Randwick Local Planning Panel (Electronic) Meeting

Development Application Report No. D75/24

Subject: 3-7 Bona Vista Avenue, Maroubra (DA/811/2023) - DEFERRED

Proposal: Demolition of existing buildings and construction of 2-storey dwelling

Figure 2: Photomontage taken from the footpath on the north side boundary of No 1 Bona Vista Avenue (Source: Applicant)

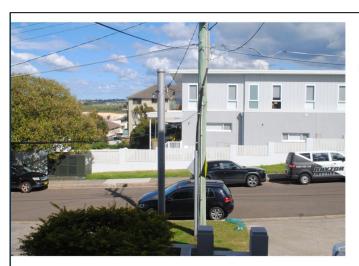
As shown in Figure 2, the bulk of the proposal as perceived from the public footpath has been significantly reduced. Although the small section of Maroubra Beach will be lost from this perspective, the additional view loss is caused by the proposed ground floor level. Furthermore, a section of the headland will be retained in the amended design.

Figure 4: Photomontage taken from rear garden of 1 Bona Vista Avenue (Source: Applicant)

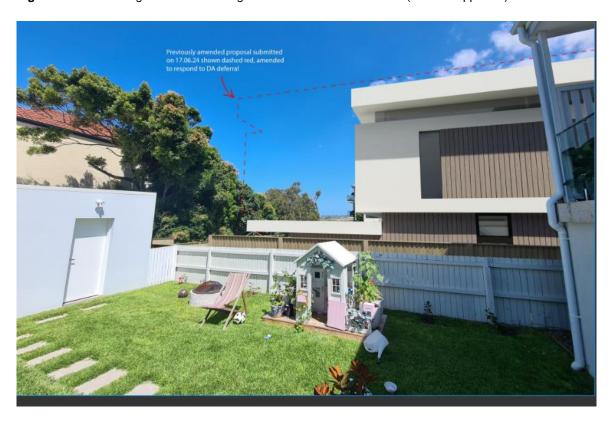
At the rear garden area from No. 1 Bona Vista Avenue, the amendments to the proposal results in an outcome whereby the outlook/view generally aligns with the rear wall of No.9 Bona Vista Avenue.

This is shown in the montage below, with the lighter grey shading showing the previous proposal considered by the Panel. Figures 5 & 6 show renders of how the building will present, with and without landscaping.

Figure 7: Photomontage taken from the rear ground floor balcony at 1 Bona Vista Avenue (Source: Applicant)

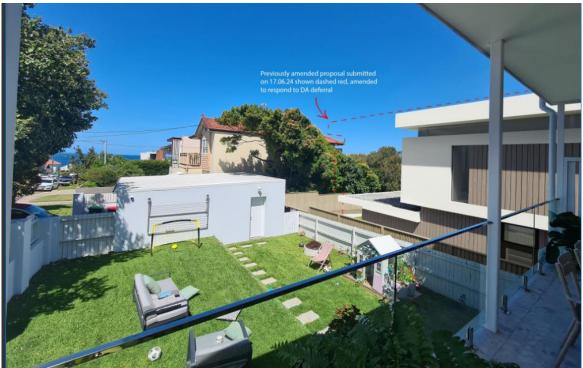
At the ground floor level, the photo taken was at the northern end of the rear balcony of that property, near the stairs connecting from the rear garden level (which is almost a level below ground floor). It is noted that this is not in the middle of the balcony and not where the outdoor dining table and chairs of that ground floor balcony are located, which is near the southern end of the ground floor balcony. Therefore, the image location does not represent the area of the balcony that will be most utilised.

This is noted because the limited existing view in the photo of the southern headland of Maroubra Beach will not exist further south on the balcony. Therefore, the view will not exist where the primary use occurs, as the rear alignment of existing RFB at No. 9 Bona Vista Avenue already affects that view corridor.

Figure 14: Northern Elevation of proposal, demonstrating the alignment with neighboring properties southern facing window (Source: Applicant)

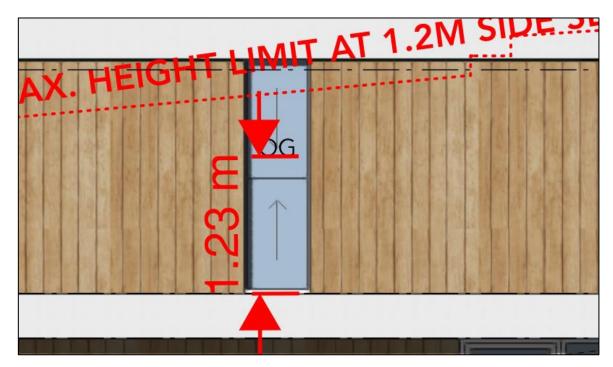
It is noted that the amended design results in the first-floor master ensuite northern facing window being directly opposite to the southern facing window at 1 Bona Vista Avenue. The Sill height at 1 Bona Vista Avenue is at RL 37.23. The floor level of the subject site's first floor is RL36.00. Therefore, it will only be the top section of the obscured glazing bedroom window, which is at the same level as the sill of the window at 1 Bona Vista Avenue. The associated impacts are considered to be minimal in this context.
